Service Bulletin

MACHINES/MODELS: All LX 31/41 Dual Fuel Work Platforms

SERVICE BULLETIN: 96.1

PURPOSE: To install three position switch in place of two position fuel selector switch. This change allows an off position to use residual fuel while changing fuel selection.

Back of fuel selector switch
Rewired with new contact block

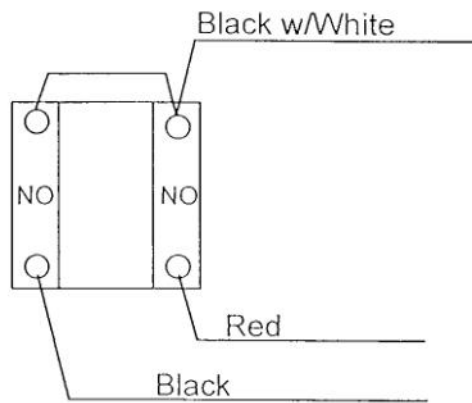
OPERATION REQUIRED: Remove existing switch operator and normally closed switch block. Replace with new three position switch operator, one new normally closed switch block and existing normally closed switch block. Rewire per instructions.

1. Disconnect battery negative terminal.
2. Open the electrical control box assembly and locate the fuel selector switch on inside of the cover.
3. Remove the three wires and jumper wire from the selector switch.
4. Remove contact blocks from selector switch and remove selector switch.
5. Remove the NC contact block from the carrier and replace with new NO contact block.
6. Install selector switch and contact blocks.
7. Rewire per attached drawing.
8. Connect battery negative terminal.
9. Check switch for proper operation. The middle position should shut off both fuel systems.
